工程指示 / 要求簡箋(E.I.)

工程指示編號：EI / 1398 / 19

工程名稱：觀塘裕民坊

工程項目：百葉 removable louver 拆圖(T2,28/F)

Section View

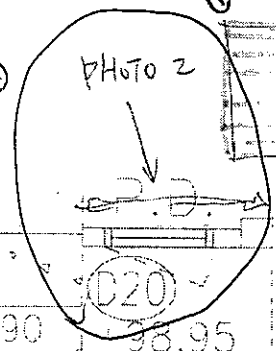
Sq. 850x500 S.O.?

change to a removable lower by Meti

1000mm (h) X 700mm (w)  
Clear  
Meti to conform PHOTO 4  
S/O size

CR - check as-builet S/O  
Meti - Operable window  
(Frosted)  
CR - 1 hr FRP format

No adverse comment to the proposed s/o 850x 500, this is for access to the flat roof for maintenance.

Please coordinate with Midi to prepare the shop drawing for the removable louvers for consultants and Sino PM review and comment.

# 28/F PART PLAN

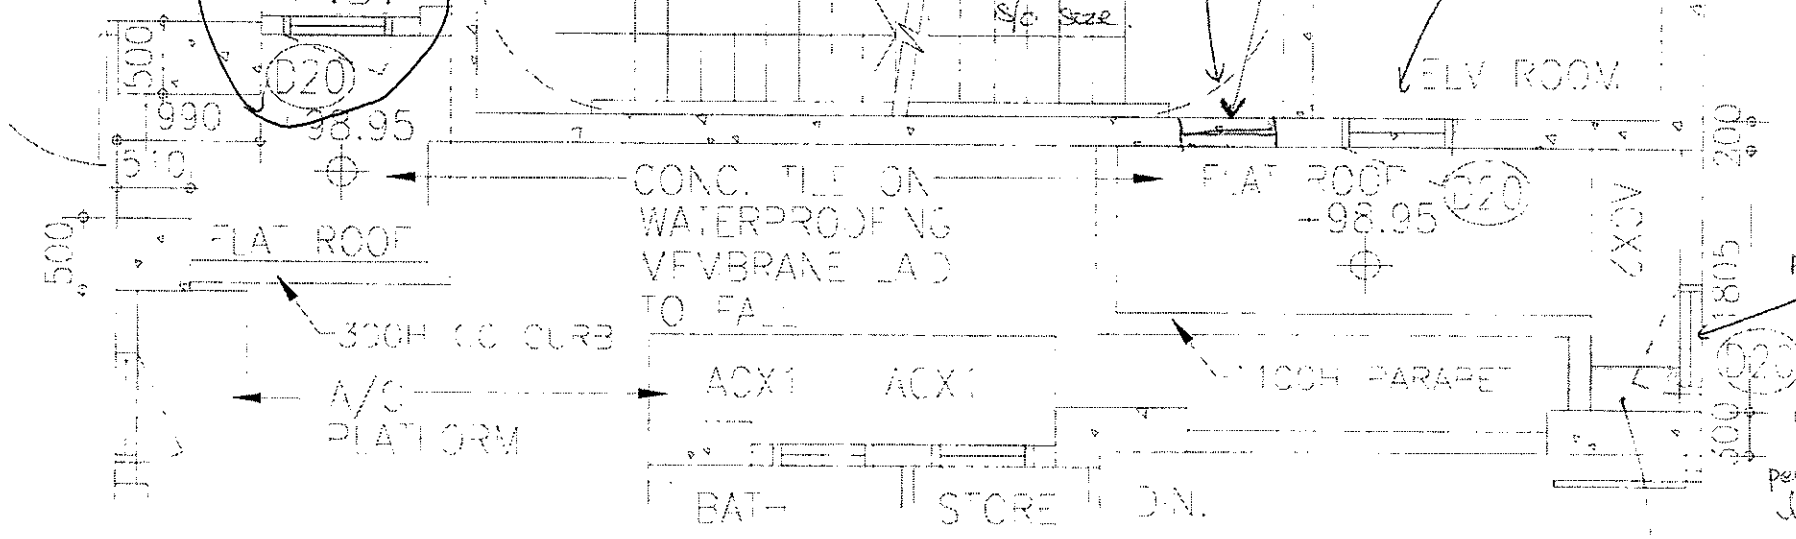
Follow drawing

SO. 850x500 PD
